# Work Order ID 116483

Item Name: Crosstube Turning Detail

<b>DART AEROSPACE LTD</b>	<b>Work Order:</b>	116983
<b>Description: Crosstube Assembly</b>	<b>Part Number:</b>	D407-667-145
<b>Inspection Dwg: D407-667-145 Rev: C</b>		<b>Page 1 of 2</b>

DRAWING NO. D407-667-145	TITLE CROSSTUBE ASS'Y (407 HIGH FWD)	REV. C	DART AEROSPACE LTD ENGINEERING ORDER		D.E.O. NO. D407-667-145-C-1	SHEET NO. SHEET 1 OF 1	SCALE NTS
DRAWN <i>q</i>	CHECKED <i>ASS</i>	MFG. APPR. <i>IS</i>	APPROVED <i>WD</i>		DE APPR. <i>##</i>		
DATE 11.07.15	DATE 11.07.22	DATE 11.07.22	DATE 11/07/22		DATE 11.07.21

**DETAIL P**  
BONDING STRAP INSTALLATION 2 PL

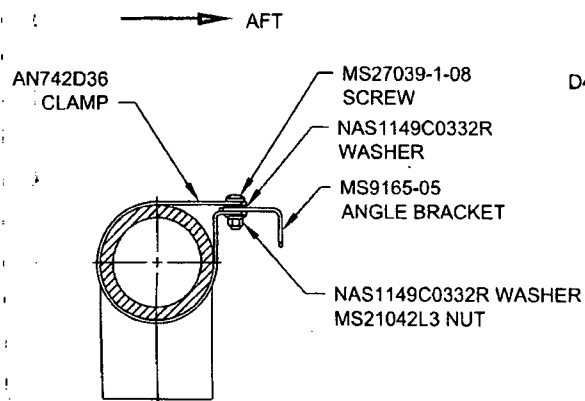
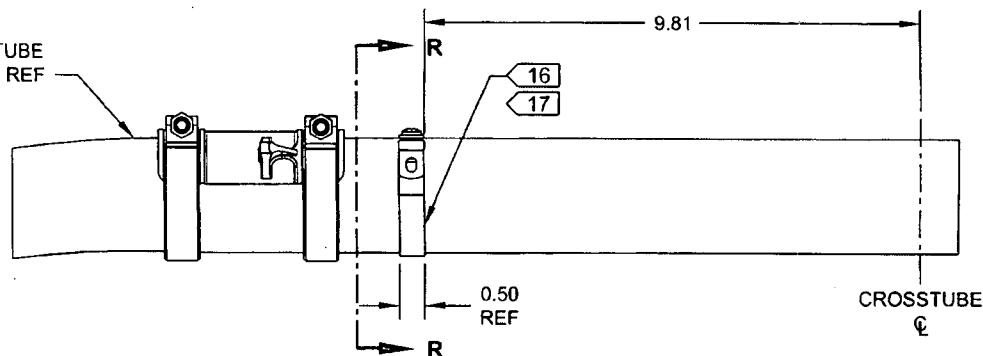
ADD ELECTRICAL GROUNDING STRAP

ITEM	QTY	PART NUMBER	DESCRIPTION
1	X	D407-667-145	CROSSTUBE ASSEMBLY (407 HIGH FWD)
10	2	AN742D36	CLAMP
11	2	MS9165-05	ANGLE BRACKET
12	2	MS21042L3	NUT (OR MS21042-3)
13	2	MS27039-1-08	SCREW
14	4	NAS1149C0332R	WASHER (OR AN960C10L)

- 16) MASK AREA UNDER CLAMP PRIOR TO PAINTING
- 17) SEAL EDGES WHERE AN742D36 CLAMP MEETS WITH THE CROSSTUBE USING SIKAFLEX-241/-291 OR MIL-S-8802 CLASS B2 OR PROSEAL 890 SEALANT
- 18) PERFORM RESISTANCE CHECK TO ENSURE MAX RESISTANCE IS 10 MILLIOHMS
